B U L L E T I N

TB 6

SUBJECT: POSSIBLE WIRING ERROR IN 96K SENSOR HARNESS

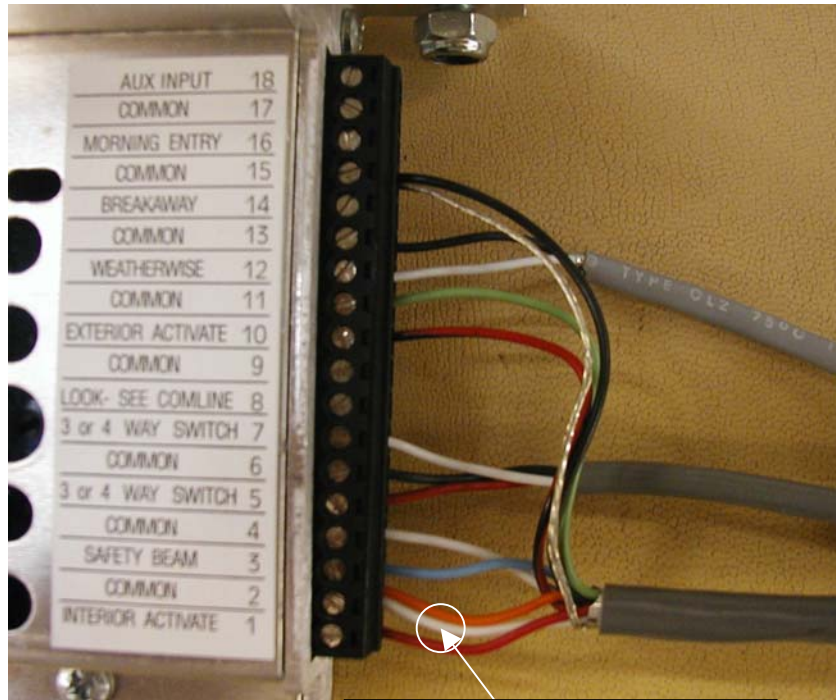
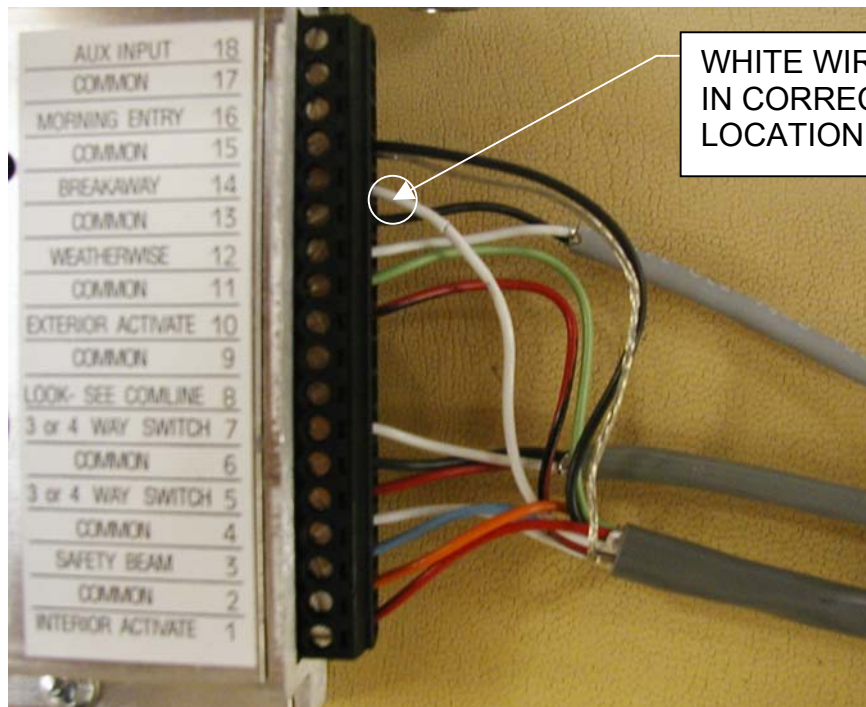
It has come to our attention that a number of 96K Sliding Door Systems may have been shipped from the factory with a wiring error in the sensor harness. The wiring error is NOT a safety concern in any way. This bulletin serves to inform our customers of the potential issue, explain the cause of the issue, and offer a solution for systems already shipped.

Symptom: Upon initial power-up, door does not operate after given an activation signal.

Cause: The sensor harness that plugs into the 96K Control Box is wired incorrectly. The wires connected to the breakaway circuit are attached in such a manner that the door control is always in breakaway mode. In this mode, the door ignores all activation signals and remains stationary.

WHITE WIRE IN INCORRECT LOCATION.

WHITE WIRE IN CORRECT LOCATION.

1. Loosen screw of connector position 2 "COMMON".
2. Remove white wire only from connector.
3. Verify that the orange wire is still properly inserted in connector position 2 and tighten screw.*
4. Insert (previously removed) white wire in terminal position 14 "BREAKAWAY" and tighten screw.*
5. Perform test of door system as outlined in 96K Instruction Manuals.

**Important note: When inserting wire into connector, care must be taken to ensure that the wire, not the insulator, is clamped down firmly when the screw is tightened.*
